CHANGE ORDER NUMBER: 1

Project: 1604-068

Roadway: Forest North Phase1

Change Order No. 1

SHEET NO.
SK25 OF SK29

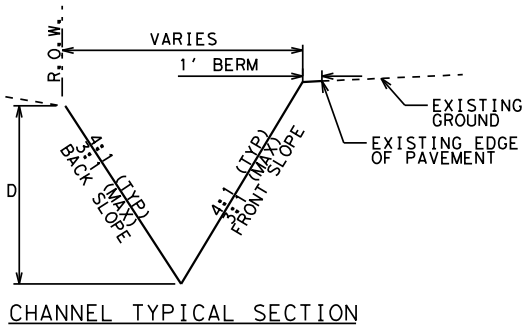
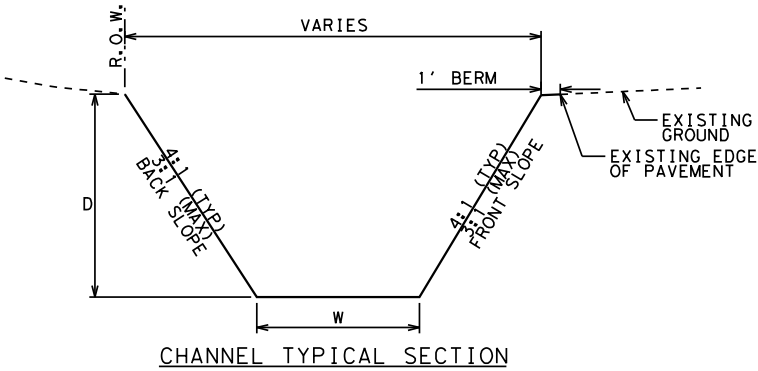
This Change Order revises drainage work along Broadmeade Avenue, between Sherbrooke Street and Meadowheath Drive in the Sherbrooke Zone. The plans show 24-inch driveway pipes downstream from a 30-inch pipe. The downstream pipe must be at least the same size as the upstream pipe to maintain the capacity necessary to drain the stormwater. Increasing the pipe size required the ditch flowline to be lowered, resulting in a rip rap lined ditch needing edge protection, per the Williamson County Design criteria manual. As a cost savings solution, the County replaced the ditch with pipe and area inlets.

SHEET NO. SK26 OF SK29

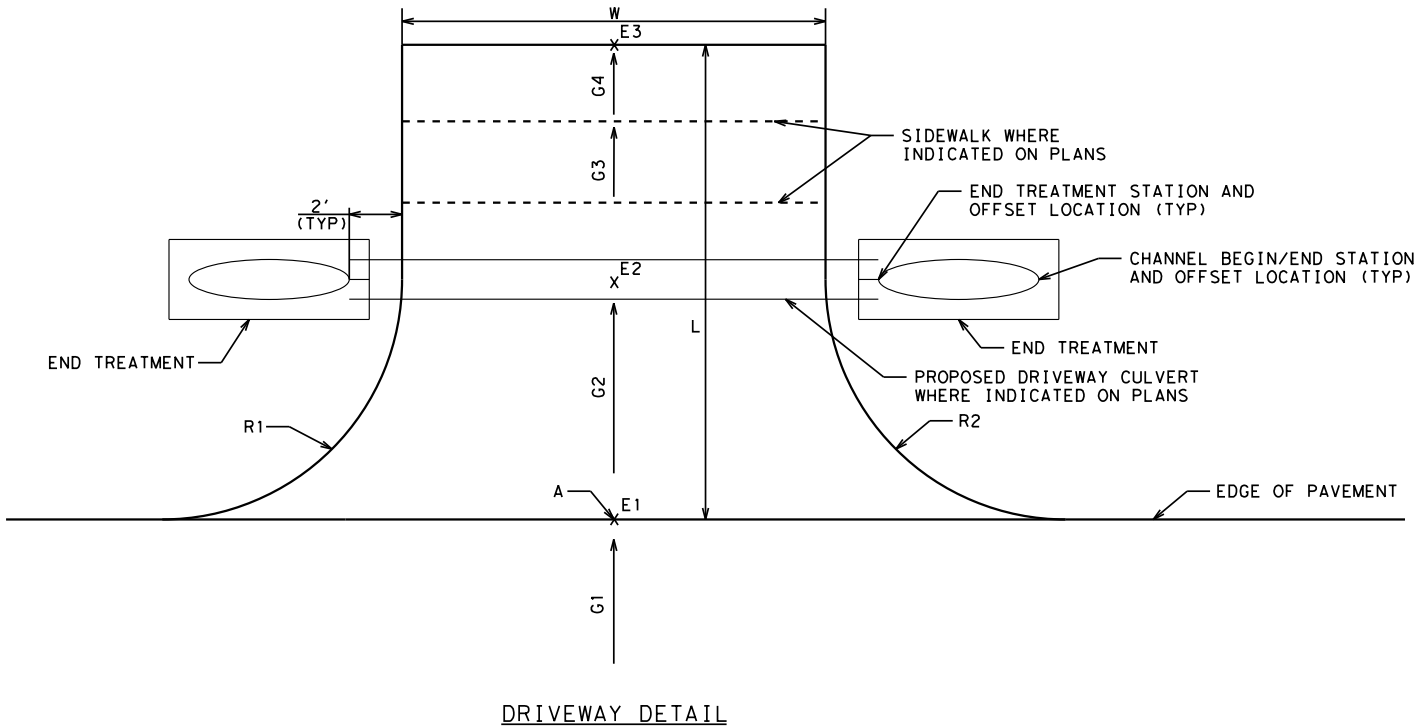
REV. NO. 1
BY WMOI
DATE 2/12/16
DESCRIPTION REVISION CHANNEL SK1-2
